UNITED STATES PATENT AND TRADEMARK OFFICE

10/805,824

Office Action Summary

DETAILED ACTION

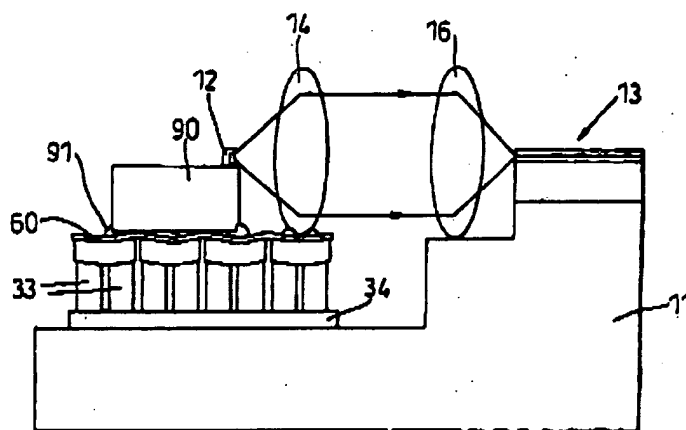
Regarding **claim 1**, Fig 9 of '143 discloses "an optoelectronic apparatus comprising:

a substrate [11] having a stepped surface having a lower and an upper portion;
a thermal electric cooler (TEC) disposed on the lower portion of the stepped surface of the substrate, the TEC having a plurality of elongated TEC elements [33] disposed substantially in parallel between a top [32] and a bottom [34] portion of the TEC, the top portion [32] of the TEC having a top planar surface that is substantially orthogonal to the TEC elements [33];

and a laser light source [12] disposed on the top planar surface [32] of the TEC."

Regarding **claims 6, 8, 23, 24**, Fig 9 of '143 discloses an optoelectronic apparatus as described above:

6. "wherein the apparatus further comprises a selected one of a driver and an

amplifier [13, 15] disposed on an upper portion of the stepped surface of the substrate [11], and coupled to the laser light source [12]";

8. "wherein the laser light source [12] comprises a laser diode device";

23. "wherein said laser light source [12] is disposed on the top planar surface of the top portion [32] of the TEC to emit light bundles in a direction parallel to the top planar surface";
